Docket Number:	17-AAER-06
Project Title:	Commercial and Industrial Fans & Blowers
TN #:	224815
Document Title:	Ingersoll Rand Comments on CEC Draft Staff Report, Commercial and Industrial Fans & Blowers
Description:	N/A
Filer:	System
Organization:	Ingersoll Rand
Submitter Role:	Public
Submission Date:	9/28/2018 2:11:23 PM
Docketed Date:	9/28/2018

Ingersoll Rand Comments on CEC Draft Staff Report, Commercial and Industrial Fans & Blowers

Re: Docket No. 17-AAER-06 – Draft Staff Report, Analysis of Efficiency Standards and Test Procedures for Commercial and Industrial Fans and Blowers

In this generic unitary air conditioner example, an increase in scroll width of 3.5” interferes with the fan wall.

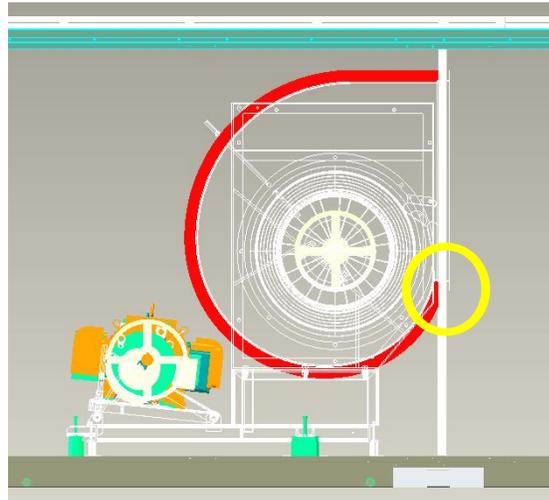
During the U.S. Department of Energy (DOE) rulemaking process to establish Energy Conservation Standards for Commercial and Industrial Fans and Blowers, DOE analysis relied on two inaccurate criteria to determine the “equivalence” of FC centrifugal housed and unhoused fans in the fan selection process. First, DOE assumed that a limited fan diameter increase of not more than 2” would yield an equivalent fan; second, DOE assumed that a 20% decrease in airflow and/or static pressure would yield equivalent fan performance. Regarding the first assumption, a 2” increase in fan diameter does not mean a 2” increase in overall fan footprint, as the complete fan housing is typically an additional 60-80% of its diameter. As an example, increasing a FC fan diameter by 2” will mean a fan footprint increase of roughly 3.5” in height, width, and/or depth. As demonstrated by the figure below of an example supply fan in a unitary air conditioner, even a modest increase in fan footprint of 3.5” can interfere with other components, such as the fan motor, indoor coils, the fan wall, or the cabinet, and subsequently require entire product redesign.

Regarding the second assumption, it is dramatically inaccurate to assume that a fan which provides a 20% decrease in airflow or static pressure is the “same” functional fan. Our customers specify product design points to provide needed airflow at a given static pressure – these requirements do not have a 20% tolerance and customers simply will not accept that level of deviation. Per AHRI Standard 340/360, the airflow supplied by the rooftop unit must be within $\pm 3\%$ of the rated airflow.

Generic VAV FC supply fan

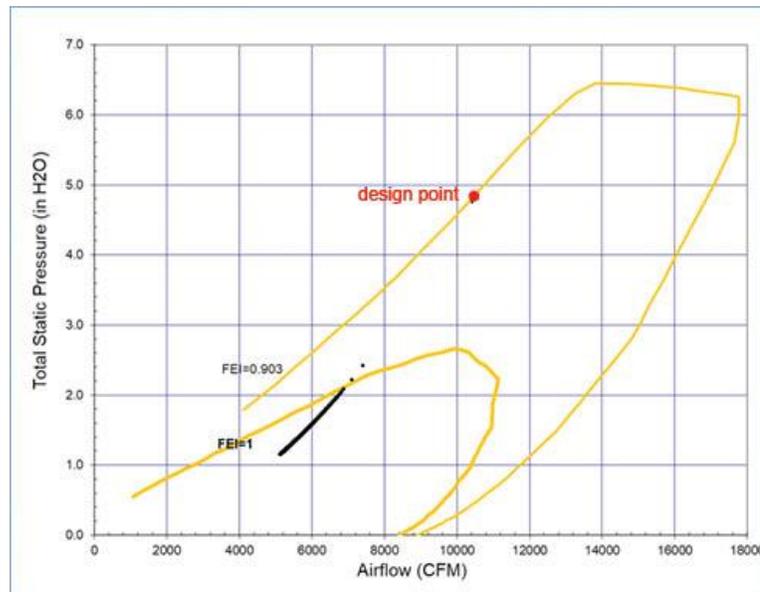
The image below depicts the certified operating ranges of a generic FC fan at FEI = 1.0 and FEI = 0.9. Each black dot is an hourly operating point for a year-long simulation of a VAV supply fan in a unitary air conditioner, serving a building in Sacramento, CA, using Trane TRACE software. At the fan design point – the point of annual maximum cooling demand for the air conditioner – the supply fan operates at an FEI of 0.903. However, because this is a VAV fan with a wide turn-down ratio, it operates over 95% of the time at an FEI of 1.0 or better, accounting for over 85% of the fan’s total energy use.

Moving to a fan with a design point FEI ≥ 1.0 will only yield meaningful energy savings at the operating points that account for around 15% of the current fan’s energy use. The remaining operating points will also see an improvement in FEI, but the incremental energy savings at those points will be substantially lower.

Dual-purpose relief fan operating map as described in the example above.

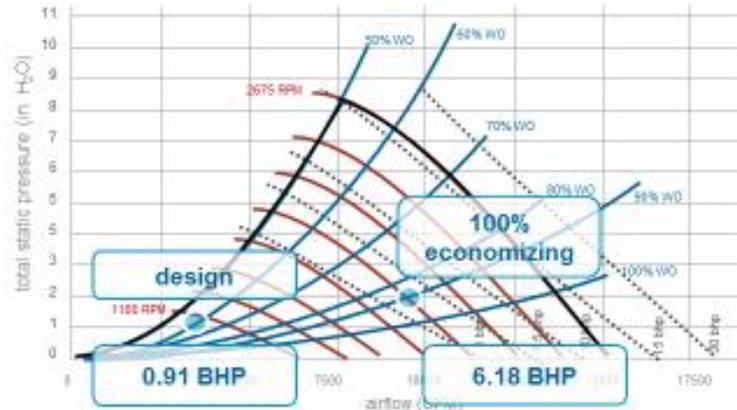
For example, suppose a rooftop unit is set up as an exhaust fan economizer system with a central supply fan and a central relief fan. 10,000 CFM is required to condition the space and the ventilation requirements are about 4,000 CFM. During design point operation, the unit returns 6,000 CFM and exhausts 3,500 CFM to maintain proper building pressurization. However, during full economizing, the unit will supply 10,000 CFM of ventilation air and must exhaust 9,500 CFM. Notice that the two operating points span almost the entire fan map. The fan needs to be sized small enough to handle the design operating point but it also needs to be selected with a wide enough operating range to handle the 100% economizing operating point.

Depending on the building type and climate, the unit will generally operate somewhere between these two points but substantial operation will be at or near the design system curve. It's worth noting that the unit may never actually run in 100% economizing mode, especially if controlled as a VAV system. The necessarily wide operating range of economizer fans cannot be overlooked if system efficiency is the end goal. Appropriate energy optimization may require estimated annual run hours with associated fan duty points.

Top view of a 70 ton Intellipak 1 unitary air conditioner

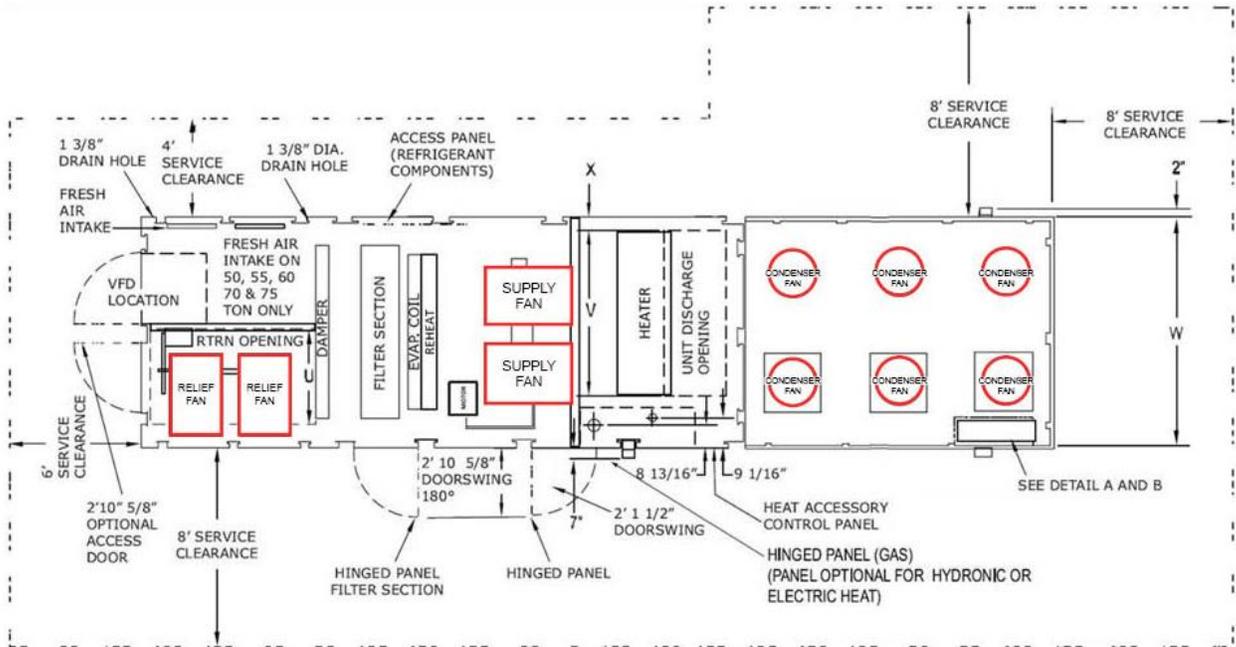
This commercial unitary air conditioner is part of the Trane Intellipak 1 product family, which offers packaged rooftop units up to 130 cooling tons (1,560,000 Btu). These products provide space conditioning to large or complex commercial buildings, such as a mid-size office or laboratory. As these air conditioners are larger than 760,000 Btu in cooling capacity, the CEC Draft Staff Report recommends regulating all fans embedded in the product, including the condenser, supply, relief, exhaust, and/or return fans.

This 70 ton Intellipak example contains the following fans:²

Fan selection: Supply Fans

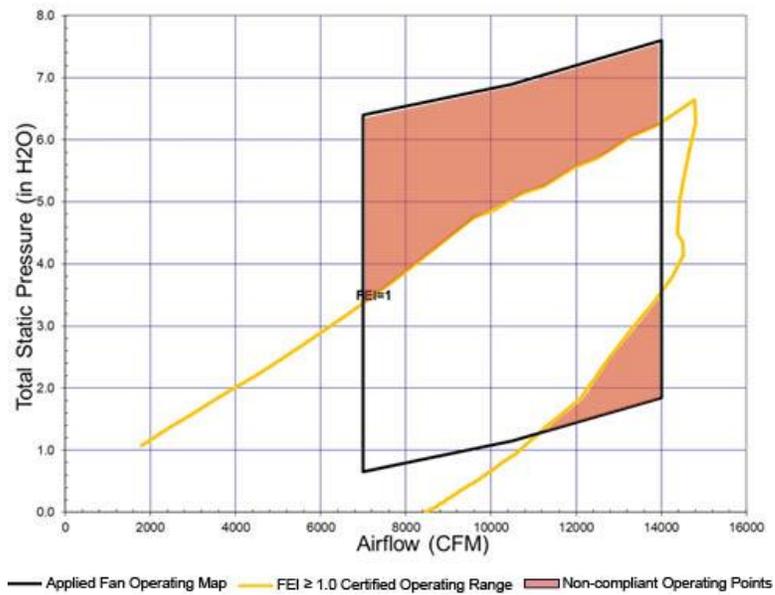
The 70 ton Intellipak currently uses two identical 22" VAV FC fans positioned in parallel. A representative fan curve is shown below; the black outline represents the fan's required operating map and the yellow outline represents a certified operating range for this fan in order to maintain an FEI ≥ 1.0 :

Since the operating map for the existing supply fan falls partially outside of the FEI ≥ 1.0 certified operating range, new fans must be selected. Moving to a 25" FC fan will move the contours of the FEI range to the left and right, but not up, and therefore will remain non-compliant for the needed operating map. A compliant fan closest in geometry will likely be a 22" AF fan.

Because of the footprint of the AF fans, it is possible that the new supply fans will not fit in the space allotted. The designer can attempt to raise the fans over top of the drive, however the increased height of the fans may interfere with the top of the cabinet. Even if the new supply fans can fit in the space, the changes in size will disrupt the relationship to the evaporation coils and the heater, both of which will become less effective as the uniformity of airflow across those elements is decreased, and ultimately they too will need to be rearranged. Further, replacement of the fan will require re-qualification of all electric and gas heating elements to ensure safe operation, as well as customer sound data testing to ensure acceptable acoustical performance. Neither of these efforts are trivial, an enormous time and resource expense will be required to complete this level of testing.

Fan Selection: Relief Fans

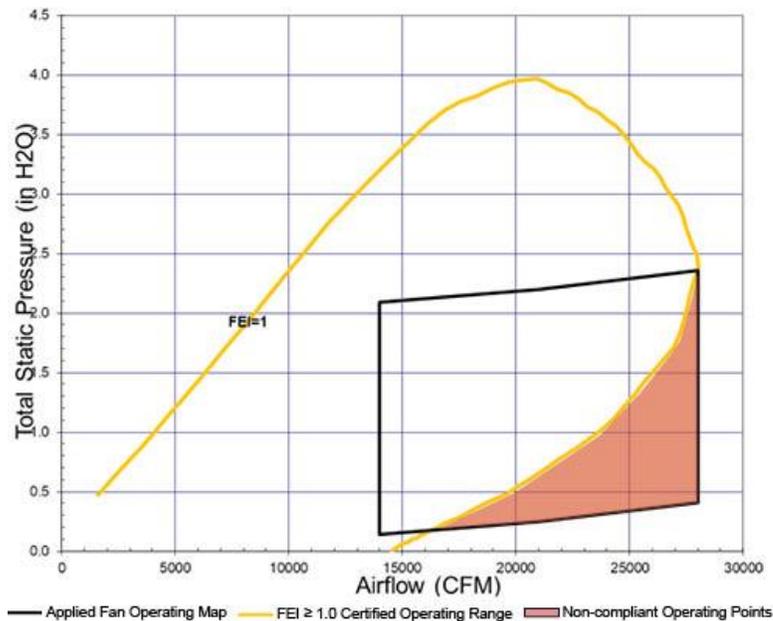
The 70 ton Intellipak uses two 20" VAV FC relief fans to discharge air and maintain balanced building pressure. A representative fan curve and operating map for the relief fans is shown below:

Just as with the supply fan, replacing the current 20" FC relief fans with 22" FC fans or 20" AF fans, as would be needed to improve the FEI, will require system re-optimization. Seeing as the relief fans are even more space-constrained than the supply fans in the 70 ton Intellipak 1, there is an increased

likelihood that the entire product will need to be redesigned with a larger cabinet size. Further, it is possible that a 22" FC fan or 20" AF fan 1.0 FEI certified operating map will still fail to cover the entire operating map of the relief fan, meaning design points would need to be restricted. Especially concerning is that the potential non-compliant points are at high airflow and low static pressure, which as stated in the previous section, are typically needed when the system is providing free cooling. As a result, the 70 ton Intellipak may have fewer operating points at which it can operate in economizing mode, and total system energy use in application will increase.

Fan selection: Relief Fan

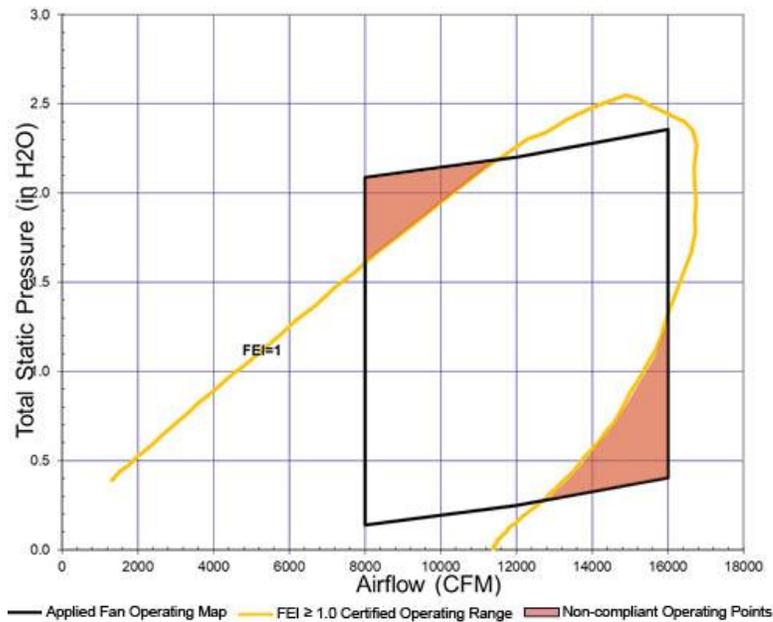
The 40 ton Intellipak uses two 18" VAV FC relief fans. A representative fan curve and operating map is shown below:

Similar to the relief fan in the 70 ton Intellipak, a new fan will need to be selected to accommodate the needed operating map, likely a 20" FC fan or 18" AF fan. Space constraints are similar for the relief

fans in the 40 ton Intellipak – they are bounded by the unit’s cabinet wall and filter section on the sides and controls behind, so product re-optimization or redesign will be necessary.
